Docket Item # 9
BAR CASE # 2008-0075

BAR Meeting
June 18, 2008

ISSUE: Alterations
APPLICANT: City of Alexandria
LOCATION: City Marina, 0 Cameron Street
ZONE: WPR/Waterfront Park and Recreation

BAR CASE #2008-0075

Figure 3. Proposed gate for Dock A-B.

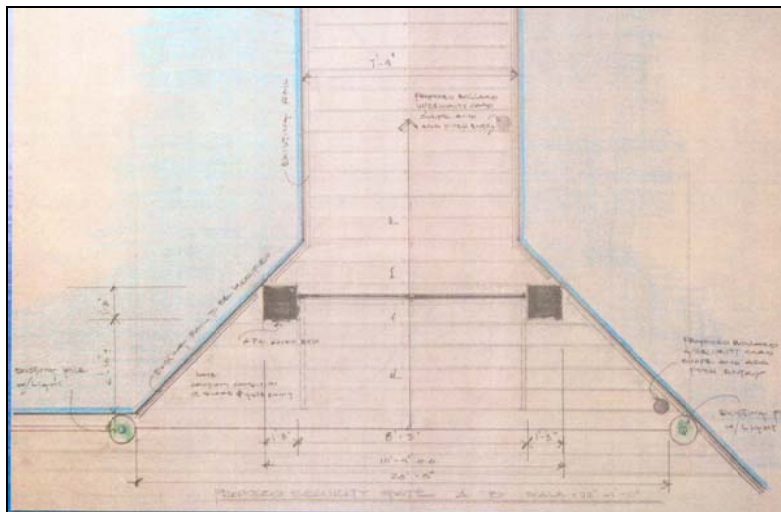
The design for the gates was inspired by the Torpedo Factory and features streamlined Art Deco elements. The gates are proposed to be manufactured of welded steel with a powder-coated, white finish. The proposed gates will measure approximately 10'9" in width by 6' in height. The operable portion of the gates will feature double gates with both vertical and horizontal bars that reflect the rectilinear elements of the Torpedo Factory. The top portion of the gates will have a stepped design, referencing the roofline at the Torpedo Factory. The two gates are joined by a large circle measuring approximately 3' in diameter, a portion of which projects above the stepped portion of the gates and forms the top of the gate. The gate features two substantial posts on either side that are 5' in height. The posts are square in plan and continue the horizontal elements at the base. The shaft of the post has an inset panel. The top of each post has a diamond-shaped element (navy blue glass with a metal frame) that will be lit by an LED light from below. The intention is to have the LED light fixture reflect upward toward the inverted pyramid planter. This will result in an angular reflective pattern. The planter will be an inverted pyramid and sit atop a ¾" thick panel of glass. One post of each gate will have a Knox Box to provide override entry during emergencies or power failure. The applicant has proposed a gate variation which contains all of the same elements except for the center circle.

Staff has no objections regarding the proposed design. The gate for Dock A-B and Dock G-H will be located at the dock entrance. To provide adequate security at Dock E-F, the gate will be located past the Seaport Foundation building. The proposed gate design represents a contemporary interpretation of the Torpedo Factory and enhances the connection between the building and the waterfront. The gate for Dock A-B has a strong physical connection to the Torpedo Factory and its design, with a prominent center circle, reflects this. The gate variation proposed for Dock E-F and Dock G-H continues many of the defining features of the gate for Dock A-B but without the circle element. The variation promotes continuity among the gates yet does not overwhelm the two docks which have a less prominent location and are in close proximity to one another. The proposed gate variation allows for a continuity of design without overwhelming these secondary docks which have a less visible connection to the Torpedo Factory.
